Project: **Mayes Gardens Apartments**

Description: **Cottage Apartments Proposal**

Drawn by:	Checked by:	Scale:
HR		1:50/250
Date:	Project No:	Drawing No: Rev:
Mar 19	18-019	02 B

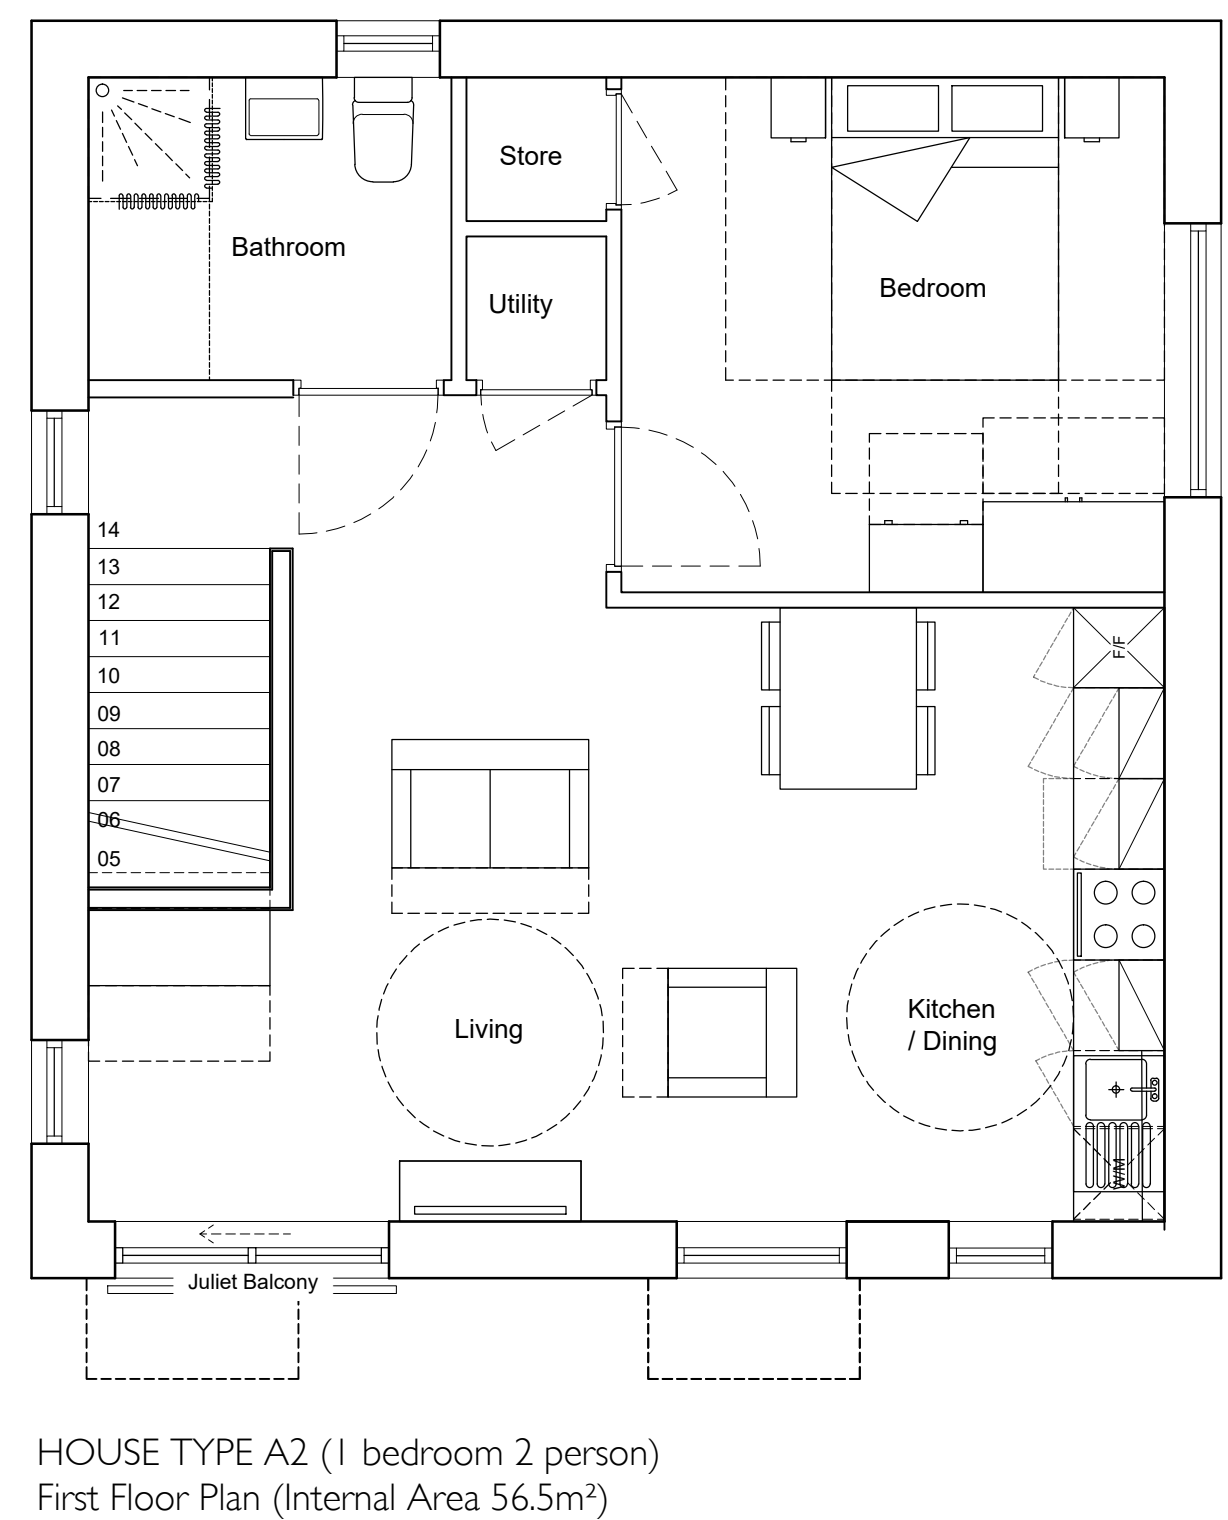
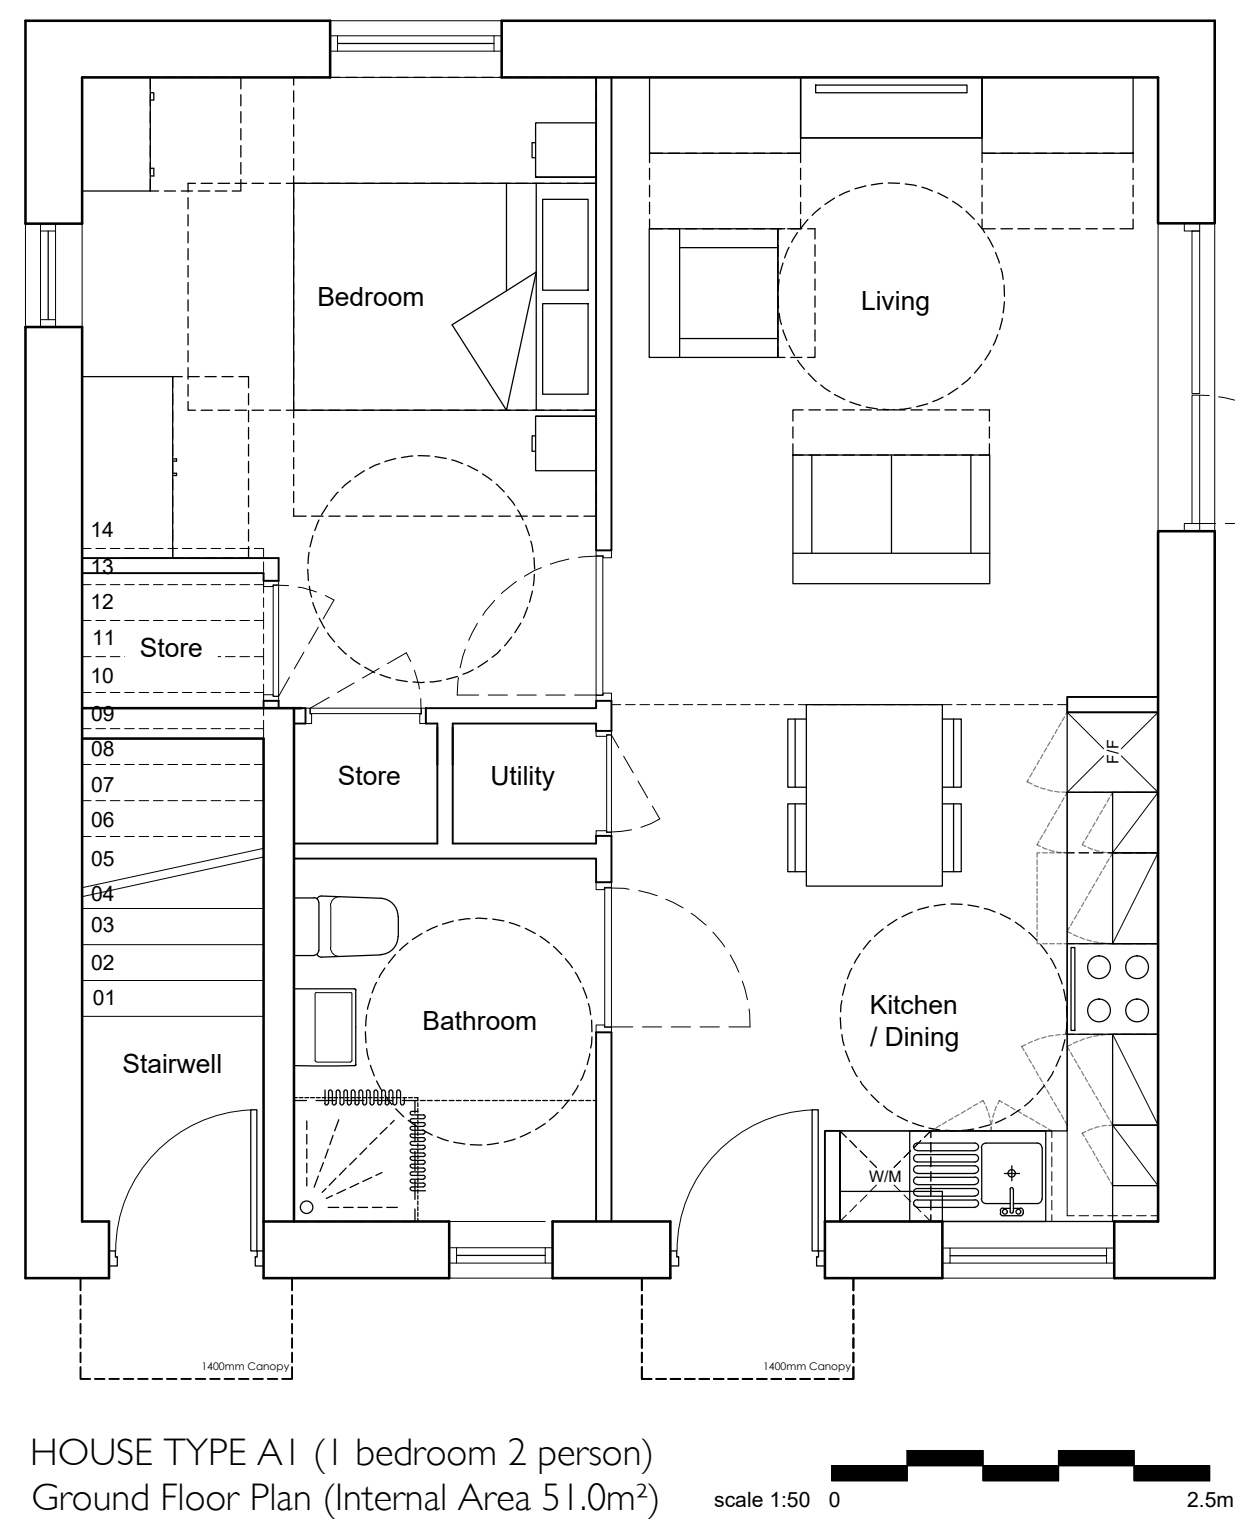
B	Balcony changed to Juliet. Bin store amended. Indicative landscaping added.	31.01.22	JS
A	Parking arrangement amended to reflect highways comments. Windows obscured with 1m removed to reduce overlooking.	08.08.19	HR
